SERVICE CAMPAIGN BULLETIN

CAMPAIGN REF: 02E
TITLE : Roll Over Valve Vent Pipe Check
DOCUMENT # : 12 K 001
AFFECTED VEHICLES : McLaren P1™

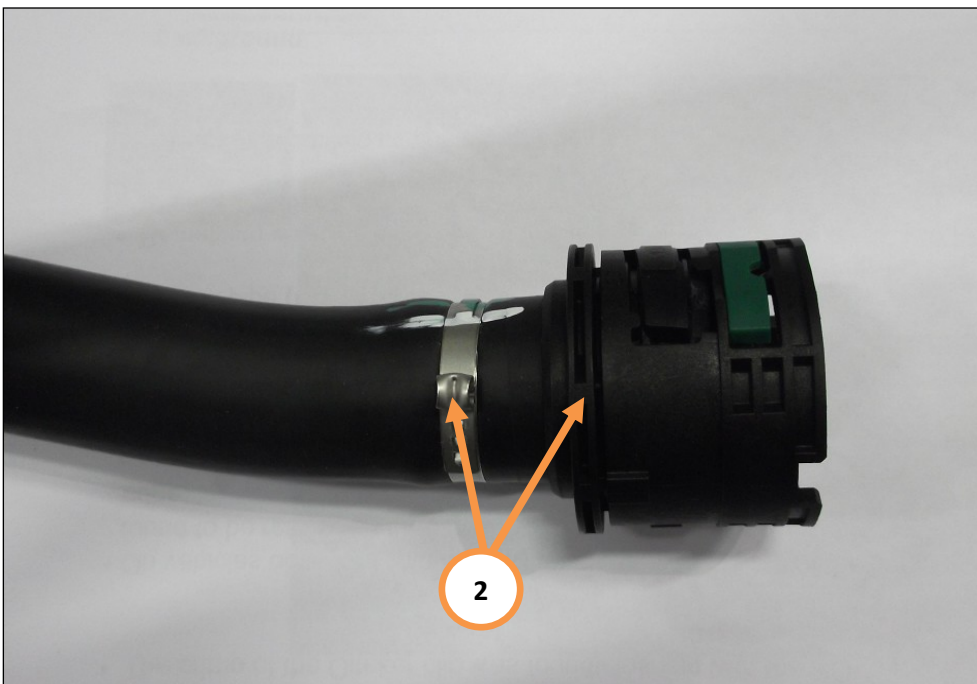
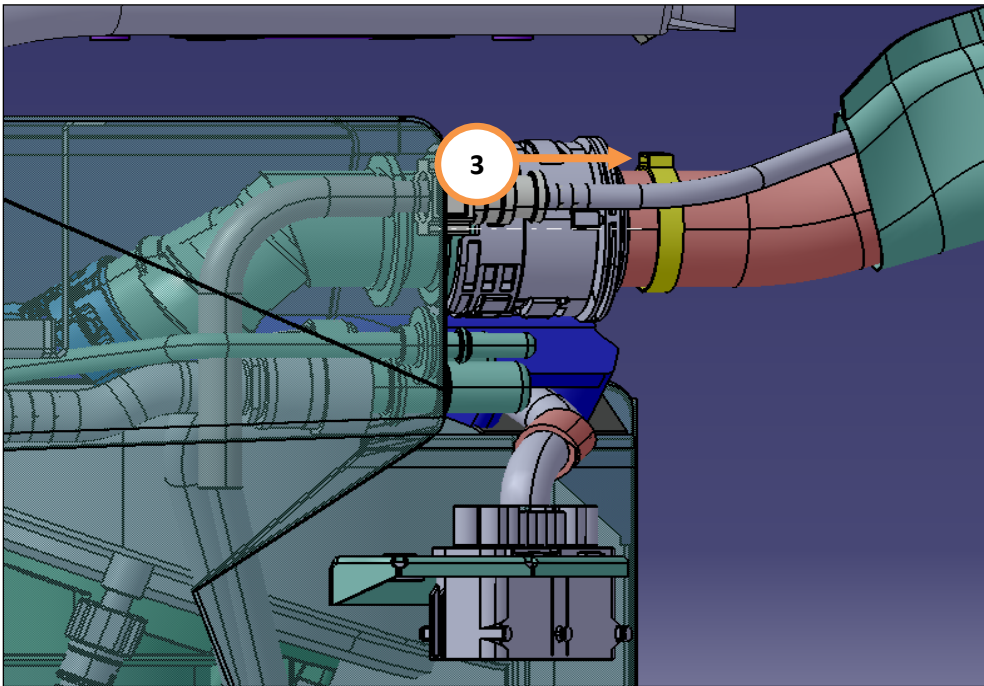
SITUATION : Quality Engineering at McLaren Automotive have identified that the fuel filler neck Oetiker clip crimp may come into contact with the roll over valve vent pipe.

1. Remove existing clip (1) from the fuel filler neck.

2. Install the new Oetiker clip 00RB123 ensuring that the crimp is positioned at 12 o'clock and aligned as below (2). Picture (3) below shows the fuel filler neck position once installed.
